re: Grading, Servicing and Landscape Plan Review
Proposed Commercial Building
30 Auriga Drive - Ottawa, Ontario

date: May 12, 2023

file: PG6513-MEMO.01

Insulation for Site Services with Insufficient Soil Cover

| DRAWING TITLE | |
|---------------------|-----------------------------|
| SITE SERVICING PLAN | |

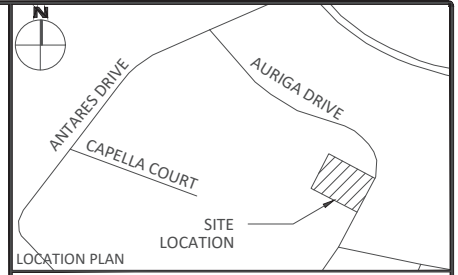
In reviewing the Site Servicing Plan, referenced above, most of the proposed services have sufficient frost cover. However, insufficient frost protection has been provided to certain storm services, where highlighted on the attached plan. Insulation of the site servicing is recommended where insufficient frost cover has been provided. Our detailed frost protection recommendations are provided below and on the attached plan.

Any portion of the proposed sewer services installed at a depth of 2.1 m below finished grade, or deeper, is considered to have sufficient soil cover for frost protection. However, based on our review, some of the proposed storm services and their subgrades are anticipated to be founded within the frost zone. Where insufficient soil cover is present above the obvert of the pipe, the following frost protection criteria should be followed:

Place a 50 mm thickness of rigid insulation over the top of these pipes, with the insulation extending 600 mm horizontally beyond the edge face of the sewer.

Place a 75 mm thickness of rigid insulation over the top of these pipes, with the insulation extending 900 mm horizontally beyond the edge face of the sewer.

All rigid insulation should consist of either Dow Chemical High-Load 40 (HI-40), Styro Rail SR.P400, or equivalent approved by Paterson. The placement of all insulation within the service trenches must be reviewed and approved by Paterson personnel at the time of construction.
